Product / Process Change Notification (PCN)																
<input type="checkbox"/> Major Change <input checked="" type="checkbox"/> Minor Change																
PCN Number: PCN_IndHEPA_20250122 Affected Series: WE-HEPA Affected Order Codes: Please see table below PCN Date: 2024-07-22 (YYYY-MM-DD) Effective Date: 2025-01-22 (YYYY-MM-DD)	Change Category: <input type="checkbox"/> Equipment/Location <input type="checkbox"/> General Data <input type="checkbox"/> Material <input type="checkbox"/> Process <input type="checkbox"/> Product Design <input checked="" type="checkbox"/> Shipping/Packaging <input type="checkbox"/> Supplier <input type="checkbox"/> Software															
Contact: Product Management Phone: +49 (0) 7942 - 945 5001 Fax: +49 (0) 7942 - 945 5179 E-Mail: pcn.eisos@we-online.com	Datasheet Change: <input checked="" type="checkbox"/> Yes <input type="checkbox"/> No Attachment: <input type="checkbox"/> Yes <input checked="" type="checkbox"/> No

Before Change:

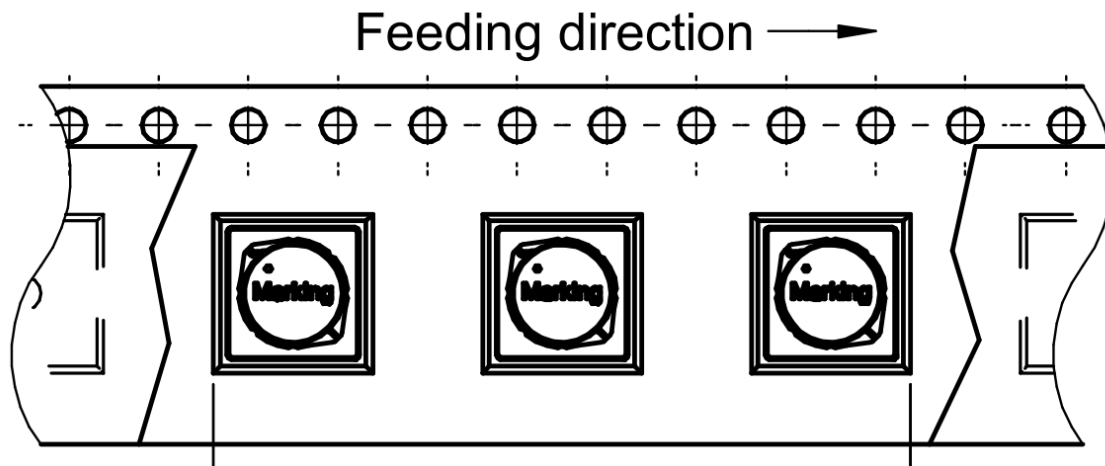
Description of Change: Because of a database mismatch, Würth Elektronik eiSos, is updating the drawing specification by rotating the component 180° in the carrier tape. There will be no change in form, fit, function, quality or reliability of the product.																
Details of Change: Affected order codes:																
<table border="1" style="width: 100%; border-collapse: collapse;"> <tr> <td colspan="5" style="padding: 2px;">Size: 5030</td> </tr> <tr> <td style="width: 20%; padding: 2px;">78408053003</td> <td style="width: 20%; padding: 2px;">78408053004</td> <td style="width: 20%; padding: 2px;">78408053006</td> <td style="width: 20%; padding: 2px;">78408053100</td> <td style="width: 20%; padding: 2px;">78408053150</td> </tr> <tr> <td style="padding: 2px;">78408053220</td> <td style="padding: 2px;">78408053330</td> <td style="padding: 2px;"></td> <td style="padding: 2px;"></td> <td style="padding: 2px;"></td> </tr> </table>		Size: 5030					78408053003	78408053004	78408053006	78408053100	78408053150	78408053220	78408053330
